ADDENDUM NO. 4  
ITB 12-026 Schooner Wharf Rebuild

**CITY OF KEY WEST  
Schooner Wharf Project  
Addendum No. 4  
July 19, 2012  
ITB PROJECT No.:12-026**

SCHOONER WHARF REBUILD ITB is amended as follows:

**ELECTRICAL RISER DIAGRAM**

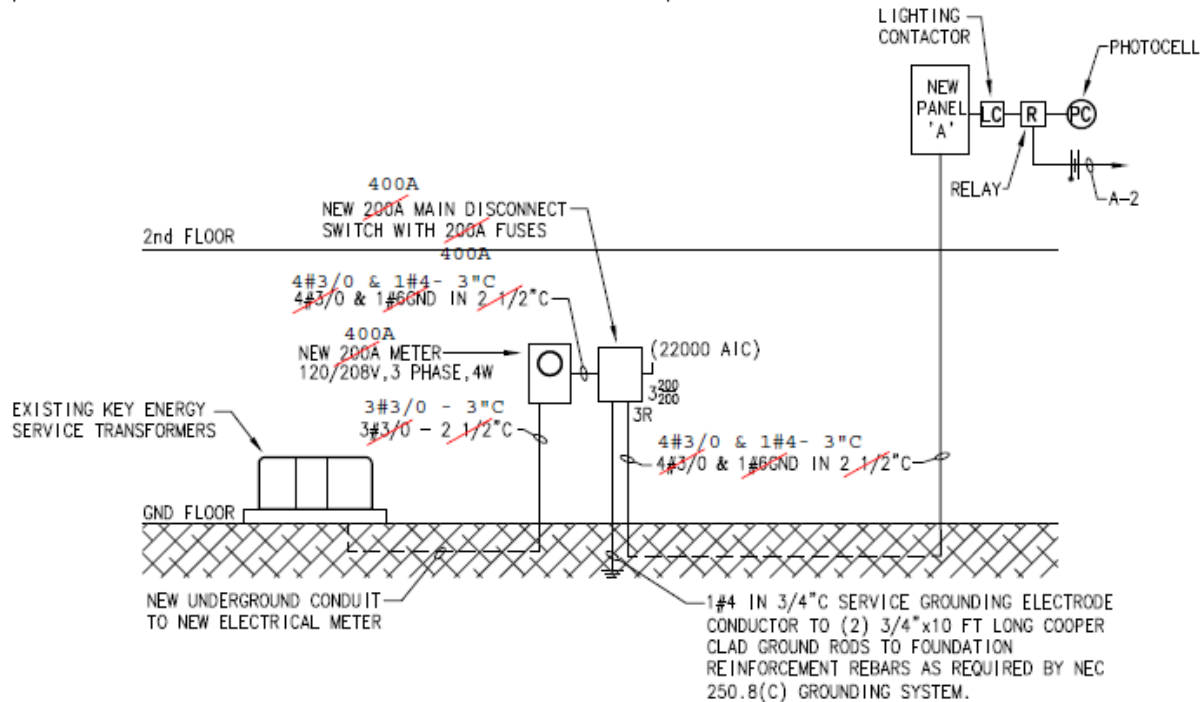
- Sheet E-4, Electrical Riser Diagram: Contractor shall upsize to a 400A Electrical Service. Meter and main switch disconnect to be upsized accordingly. Work will include adding (5) additional receptacle, including conduit and wires (conduit: 3/4"C, wire size: 2#6,1#1G), along the tie beam of the north side of the new structure. Meter, main disconnect, wire and conduit should be priced per redlines shown below on the riser diagram.  
**ADD Alternate:** Contractor should include a separate price to add a second panel 'B' 200A, include upsized conduit, wire, meter, main disconnect switch and all else necessary for a complete and functional installation. Second panel 'B' shall be installed next to the proposed New Panel 'A'.
